DEVELOPMENT APPLICATION ASSESSMENT REPORT

Application Number:	DA2021/1017
----------------------------	-------------

Responsible Officer:	Phil Lane
Land to be developed (Address):	Lot 2 SP 43819, 2 / 24 Plateau Road COLLAROY PLATEAU NSW 2097
Proposed Development:	Alterations and additions to a Dwelling within an attached dual occupancy development
Zoning:	Warringah LEP2011 - Land zoned R2 Low Density Residential
Development Permissible:	No
Existing Use Rights:	Yes
Consent Authority:	Northern Beaches Council
Land and Environment Court Action:	No
Owner:	The Owners of Strata Plan 43819
Applicant:	Add-Style Home Additions

Figure 3: Demonstrates good side relief to the southern boundary and good articulation

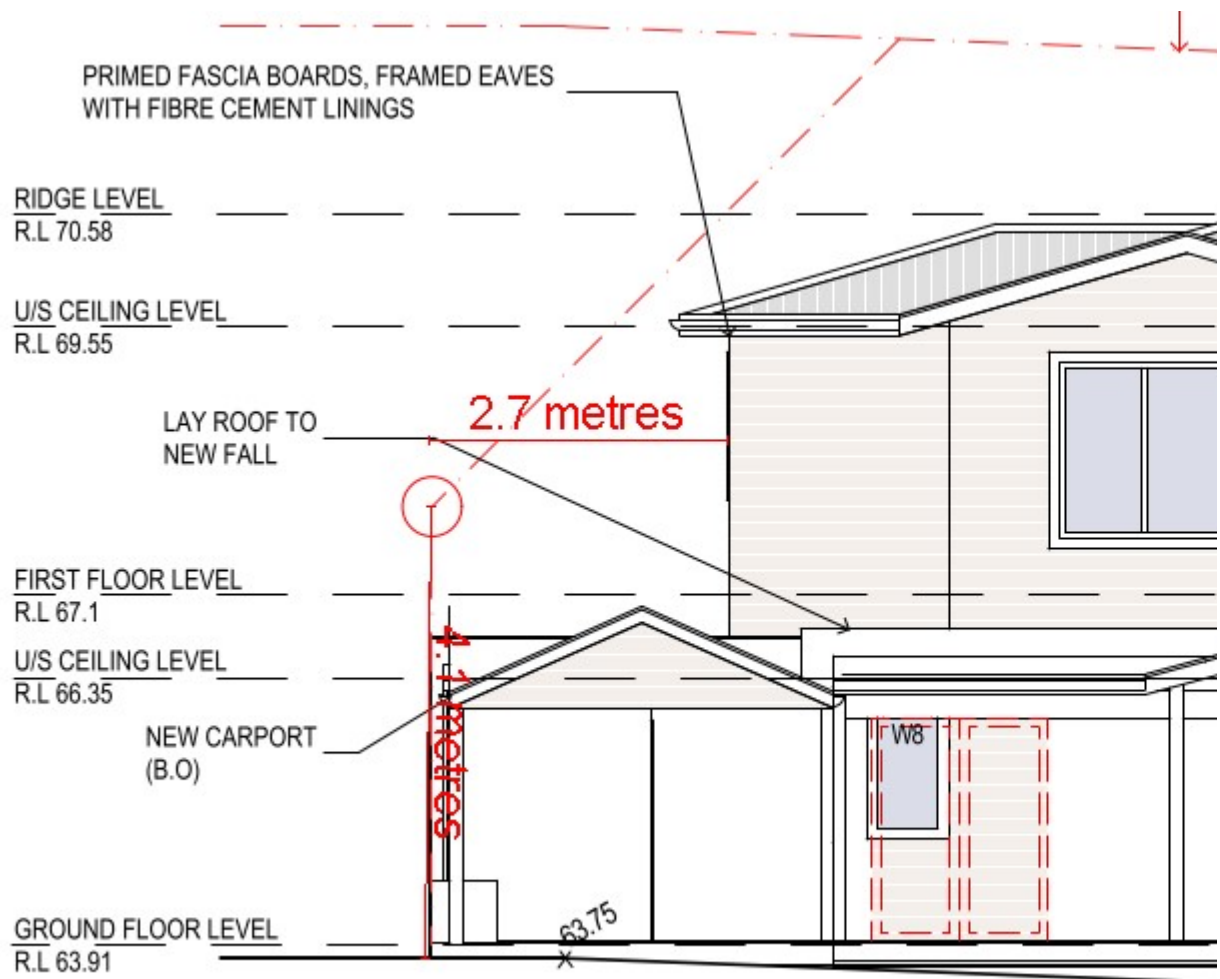
"Based on the NORTH ELEVATION of the master plan this indicates that the new structure will

proposed structure."

Comment: The proposed first floor is very modest in size (only 53.9sqm in area as demonstrated above in Figure 2) and is fully compliant with the building height, wall height, rear and side setbacks. The proposed building height is 7.1m (overall) and is 1.4m below the allowable height limit of 8.5m. The proposal is non-compliant with the southern boundary envelope control and this has been addressed in the report. It is noted that the first floor is stepped from the ground floor level demonstrating a setback of 1.4m from the southern side boundary (see Figure 3 below) ensuring the development demonstrates good articulation and spatial separation to the dwelling at 22 Plateau Road.

Given the above it is considered that this matter does not warrant refusal and/or amendment via condition(s).

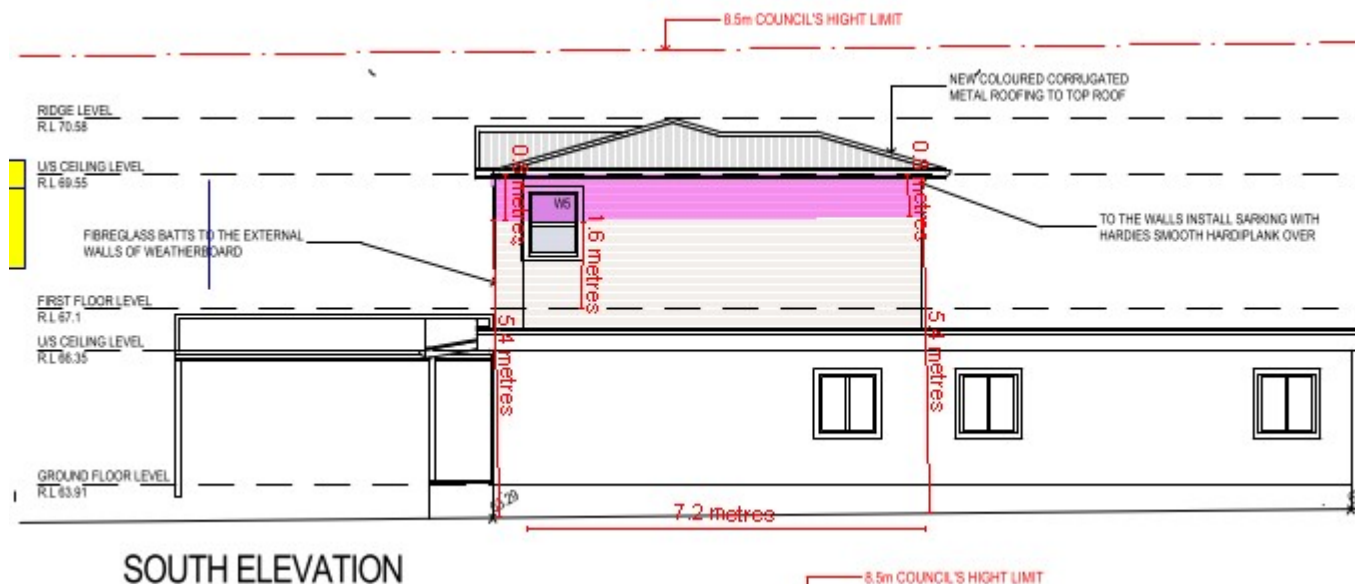
The control requires that a building must be sited within the building envelope which is determined by projecting planes at 45° from a height of 5m above the ground level at the side boundary.

The proposed first floor encroaches into the side boundary envelope along the southern elevation to a height of 0.8m for a length of 7.2m, representing a minor variation of 20%.

The dwelling is compliant with this control on the northern elevation.

The proposed non-compliance with the building envelope control is not found to cause any unreasonable visual impacts. The proposed works are situated within the existing building footprint and below the maximum permissible building height. The proposal is also appropriately setback from the side boundary and is sufficiently articulated to satisfy the objective. The overall built form is generally consistent with that of surrounding development.

Having regard to the above assessment, it is concluded that the proposed development is consistent with the relevant objectives of WLEP 2011 / WDCP and the objectives specified in s1.3 of the Environmental Planning and Assessment Act, 1979. Accordingly, this assessment finds that the proposal is supported, in this particular circumstance.
